UNITED STATES PATENT AND TRADEMARK OFFICE

APPLICATION NO.	FILING DATE	FIRST NAMED INVENTOR	ATTORNEY DOCKET NO.	CONFIRMATION NO.
10/070,642	03/11/2002	Martin Hartung	1860/50916	9210

Office Action Summary

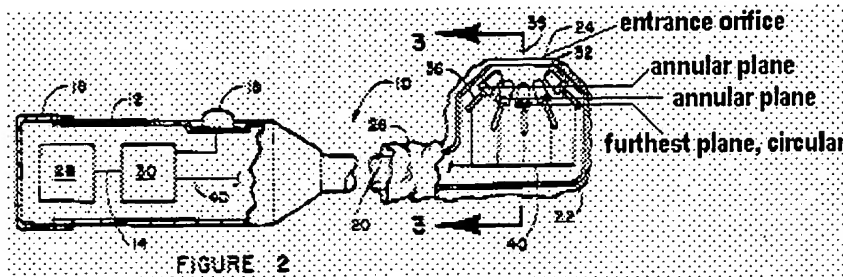
Claims 18-24, 27 and 36-38 are rejected under 35 U.S.C. 102(e) as being anticipated by Osterwalder et al (US 6,102,696).

Note the identified structure below in Osterwalder et al Figure 2. In regard to the limitation that each light-emitting element have a "light cone", "aperture" and "optical axis," it is noted that applicant discloses conventional packaged diodes just as Osterwalder et al does and thus it is presumed that the Osterwalder et al packaged

diodes also meet the limitations. In regard to the "light conducting unit limitation" window 24 of Osterwalder et al conducts light.
